Re: ACTION RE: PETITION FROM DAN ROARTY REQUESTING FINAL PLANNED DEVELOPMENT DISTRICT APPROVAL FOR COMMERCIAL/RESTAURANT AND MICROBREWERY/TAPROOM ON PARCEL AL-44, LOCATED AT 1649 S. WEBSTER AVENUE (former Village Hall property)

# Final Review of Planned Development District – Staff Comments

**Site:** 1649 S. Webster Avenue (Parcel AL-44)  
**Development:** Restaurant and Zambaldi Brewery and Taproom  
**Developer Representatives:** Dimension IV – Dan Roarty AIA, LEED AP – Principal and Senior Architect; Mach IV – Bob Mach – Engineer; Mike Cashman – DeLeers Construction; Zambaldi Brewery – Abigail & David Malcolm – Malcolm Management LLC.

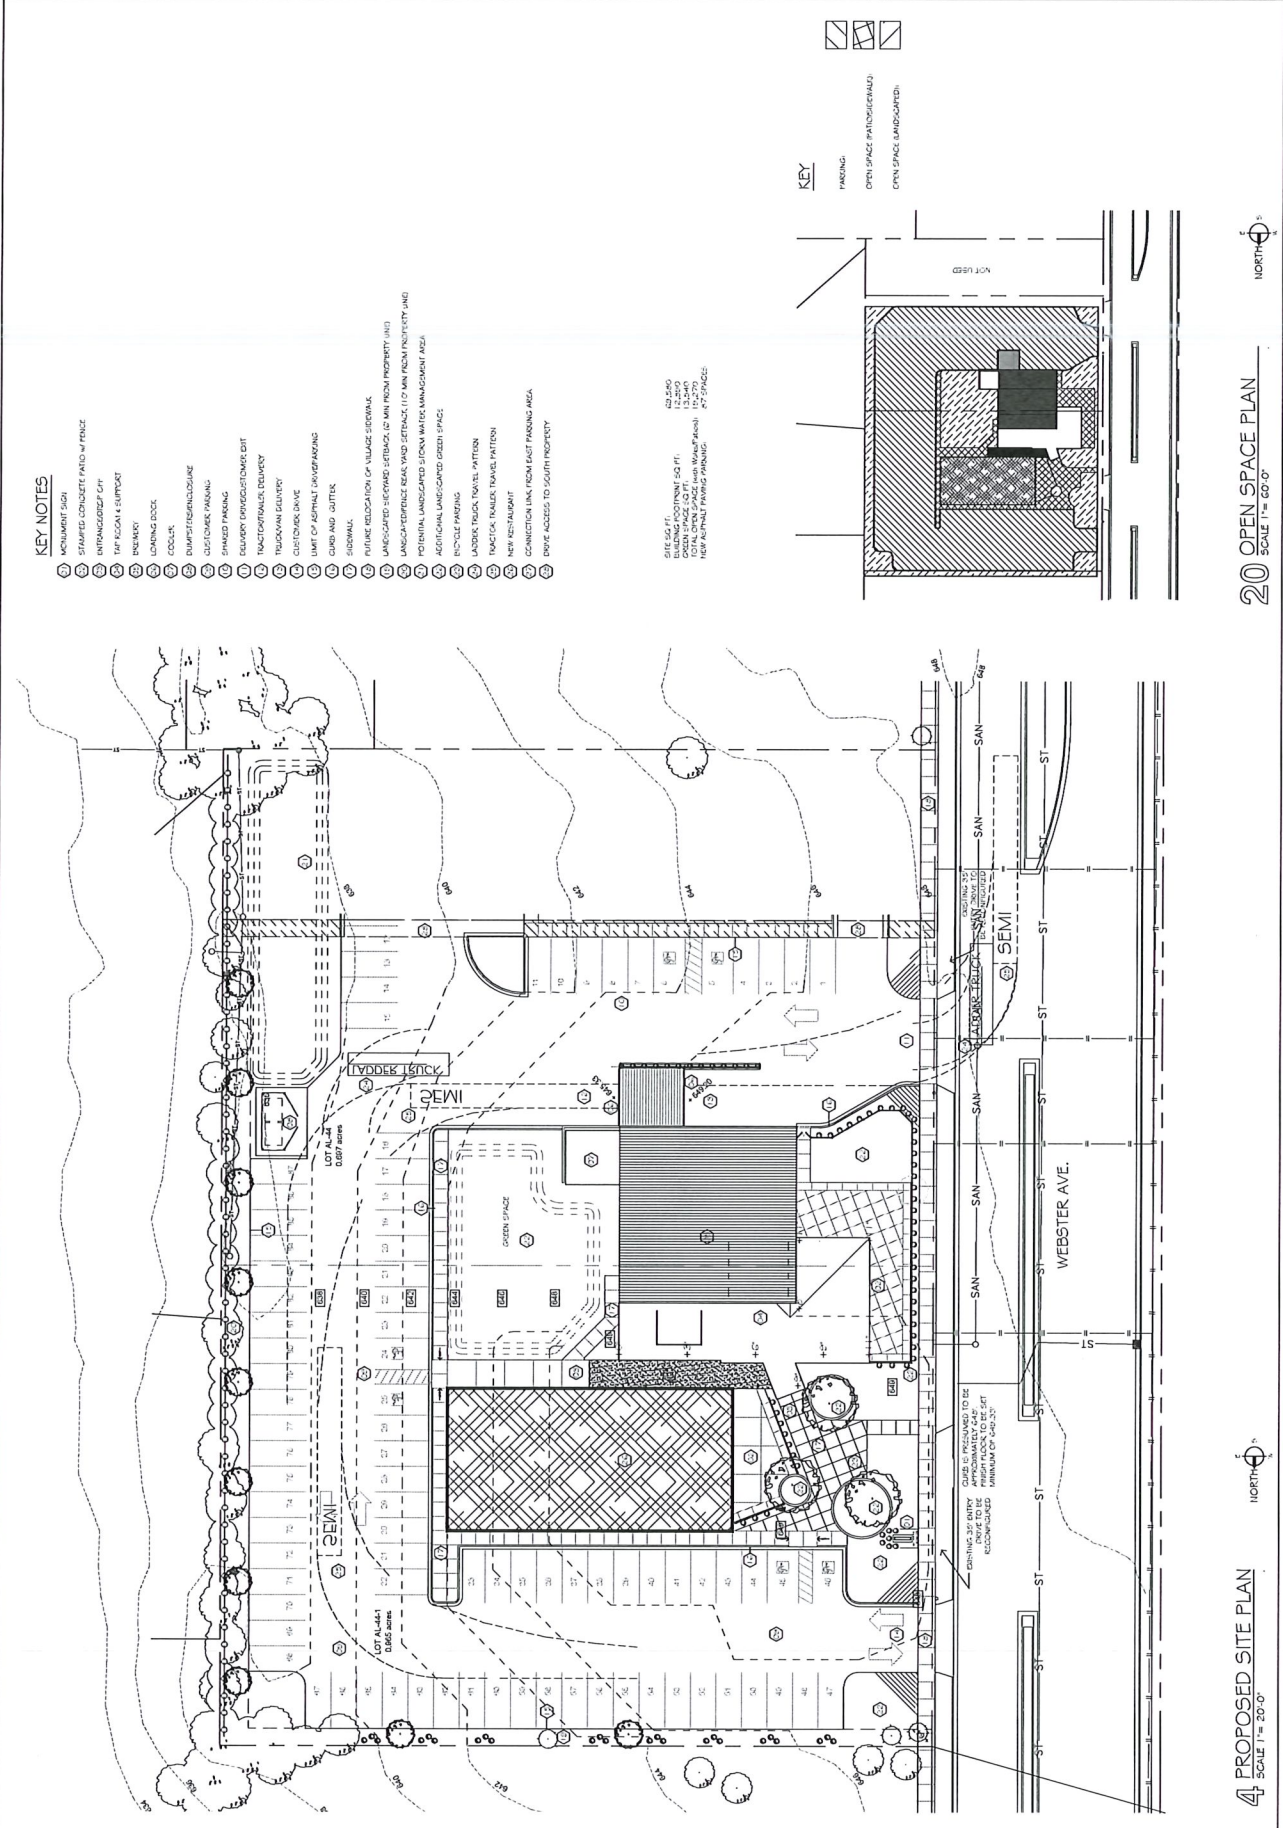
Zoning district (proposed)		Commercial District		
Building use (allowed by CUP)		Restaurant/Tavern and Industrial Manufacturing (Brewery)		
		Required	Provided	Notes
Height		Lesser of 50' or 4 stories	22'8"	
Lot	Area	No minimum	69,580SF	
	Frontage	No minimum	284'	This frontage amount is less 6' from the total parcel amount. 6' will be provided to adjoining property to the south.
	Green space	No minimum	19.46%	This percentage assumes 6' of the property will be acquired from the village for additional sidewalk area on Webster Avenue. The total open space is 27.69% of the site.
Setback	Front	15'	Standards met	
	Side (inner)	6'	Standards met	
	Side (corner)	N/A	N/A	
	Rear	10'	Standards met	
Parking	Number	<u>Restaurants and taverns</u> (1/100SF + 0.5/employee on shift) <u>Industrial or manufacturing establishments</u> (greater of 1/1000SF or 0.5/employee)	7 (14 employees) + 30 (3000SF Taproom) + 5 (4770SF Brewery space) + 53 (5300SF Restaurant)= 98 spaces required	87 spaces provided.  Written perpetual parking easement agreement will be established with the parcel to the south. The plan for the southern parcel is for a daytime office development.

Size	10'x20'	Not provided	Stall dimensions are not provided in the plans, however, the developer has told staff that dimensions will be 9'x18' and 9'x20'
	Bicycle	Bicycle parking should be provided	Standards met	Recommend a bicycle rack which accommodates a U-shaped lock and the ability to secure the bike frame and both wheels. Also maintain the rack out of the pedestrian zone.
Off-Street Loading Requirements		Screened from residential uses Areas should be surfaced with bituminous asphalt or concrete Screened from adjacent uses at minimum 5' from final grade	N/A Standards met Metal railing shown. Fence shown at property line.	Detail of what the fence will look like should be provided if required.  Loading dock should be screened from street and adjoin property to the south to the greatest extent practical.
Access	Automobile	24' drive lanes with 90 degree parking, 18' for 60 degree, 14' for 45 degree	Not provided	Ladder firetruck and semi-truck traffic patterns are shown. Consideration should be given to the location of the dumpster enclosure and the maneuverability of the trucks.

Pedestrian	ADA compliant sidewalks	Not provided	Preferred to not have parked vehicles overhang to make the sidewalk less than 5' wide. ADA ramp should be provided at handicap parking hashed lines.
Architecture		Varied rooflines and other architectural designs that break-up the building mass	Standards met	Revised renderings or side and rear elevations are not provided to include the restaurant addition.
Exterior finishes		Brick, stone, glass, fiber cement siding, EFIS, stucco, wood siding	Stone, Corrugated metal, insulated panel	Corrugated metal may be allowed if approved by the Plan Commission and Village Board, but large, unbroken sections should be avoided and thick, durable grade siding should be used. Insulated metal panels are being proposed for the

walk in cooler in the rear.
Lighting		Dark sky compliant, no light directed towards ROW, no more than 0.5FC at commercial property line or 0.2FC at residential property line, must be shut off at 10p.m. or at time of closing.	Not provided A lighting plan is not required by ordinance for plan approvals, but a plan must be provided and approved with other building plans.
Sign	Monument	32 SF/side (64 SF total) Setback 15' from a driveway Street address on the base of the sign (minimum 5" numbering) Decorative base at least 2' high of same or similar materials as principal building 2' landscaped area surrounding base	Not Provided Not provided Not provided Not provided Sign appears to meet village standards. However more information will need to be provided before final approval. Signs are likely to change with additional tenant(s).  Signs are typically approved through staff review and the information does not need to be known at this time, unless the developer is seeking signs that are above and beyond village standards. Variance from the sign code is allowed through the PDD process, but more detail should be provided.

Wall	1 wall sign per business Primary wall signs shall be no larger than 15% of the business street frontage. Total area cannot exceed 0.5 SF/lineal foot of lot frontage. Wall signs cannot extend further than 18" from the wall	Not provided
	LED Message Center	N/A	N/A
	Illumination Standards	N/A	N/A No lighting is being proposed at this time. If lighting is used, the sign should be shut off at 10p.m. or time of closing with lights. Must meet all other sign requirements.
Fences/Screening		6' wide landscaped area on border of residential lot, with 1 tree/35', and berm, fence, wall, or landscape barrier between 6'-8' high and 90% opaque; dumpster must be located at rear and be screened using same finishes as primary structure; mechanical equipment must be screened from street	Not provided Plans are to keep existing chain-link fence and vegetation, with additional tree 1/35'. Waiver may be granted by the Village Board for screening from residential lot with neighbor's written permission. Consent has been received from adjoining residences.  Dumpster exhibit not provided.

- Snow storage is planned for the greenspace to the rear (east) of the property.
  - Written perpetual parking, egress, stormwater, and garbage easements will be established between the parcel and the parcel to the south.
